E6651A-03

**S E R V I C E N O T E**

E6651A Mobile WiMAX™ Test Set

**Instrument Display Not Properly Aligned**

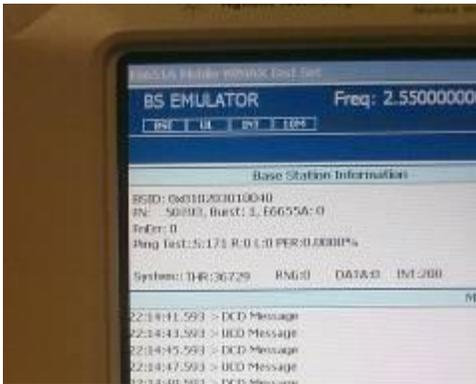
The E6651A display is auto-aligned by a step that was recently added to the manufacturing process. Instruments shipped before this step was added may exhibit a slight offset in their display.

Figure 1 shows an example of an instrument that has not been auto-aligned. In this instance the display is visibly shifted to the left by several pixels, causing the leftmost columns to be cropped.

Figure 2 shows the same instrument display after auto-alignment. The leftmost characters are now clearly visible, as is the grey border around the “BS EMULATOR” frame.

This auto-alignment procedure can only be carried out at a Service Center, as some disassembly is required in order to access the front panel control buttons.

1. Remove the screws attaching the front panel to the chassis.
2. Extend the front panel on its sliding rail.
3. Switch on the instrument, and wait for it fully boot-up.
4. Briefly press the second button below the LED (see Figure 3).
5. The display will immediately be auto-aligned, and a few seconds later the “OK / Cancel” popup message will disappear.
6. Switch off the instrument and re-attach the front panel to the chassis.
